TT396: 1125R Instrument Cluster Software Changes

November 24, 2008

1125R Instrument Cluster Software Changes

Figure 1.

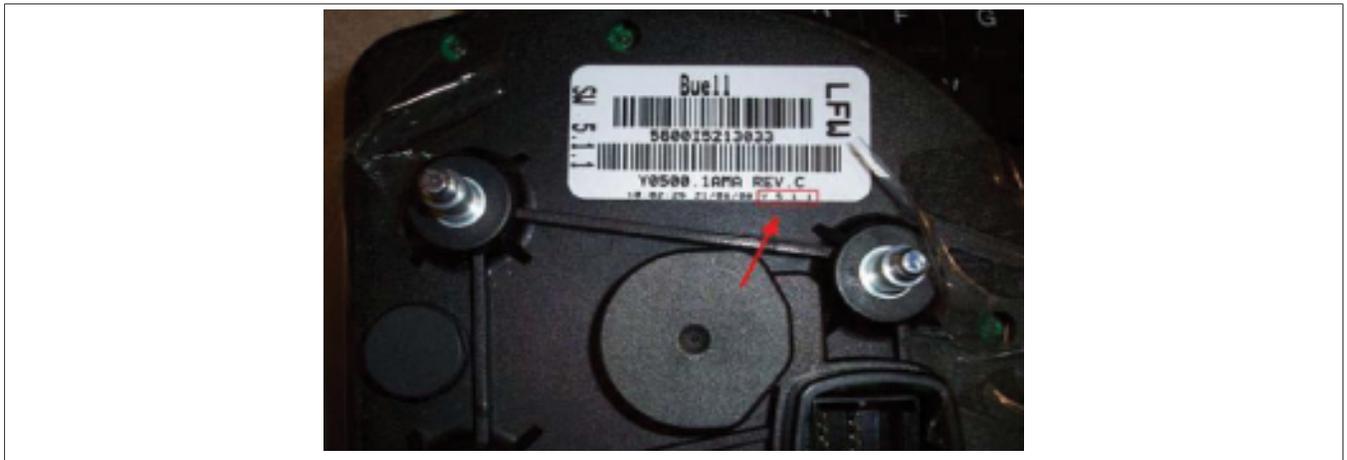
Early instrument clusters only display the software level on the rear of the module. (see image below) A software version of 5.1.1 includes upgrades to prevent the abnormal draw and should NOT be replaced for draw related issues.

If you are unable to locate a draw on the vehicle and the cluster software version is below 5.1.1, i.e. 4.1, 4.2, 4.3..., the instrument cluster should be replaced.

Figure 3. A Software Level of 6.1

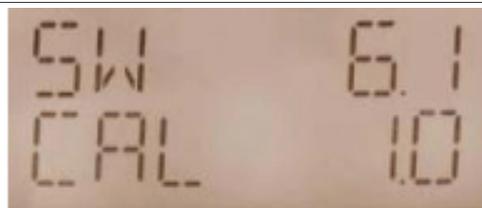
Later instrument clusters allow you to verify software level on-board via the diagnostic menu. To get into the diagnostic menu, key-on while holding the Toggle and Mode buttons simultaneously. A quick reminder though that if the instrument cluster is new and has not yet been powered up for 30 minutes to synchronize, you can NOT enter the diagnostic menu. The last screen of Live Data items will be the software level. (see image below)

Verify the software version as well if you are diagnosing inaccurate low fuel warning lights. Issues were identified with the Software Version 5.1.1 and 6.0 that could lead to a low fuel light coming on intermittently with adequate fuel levels.
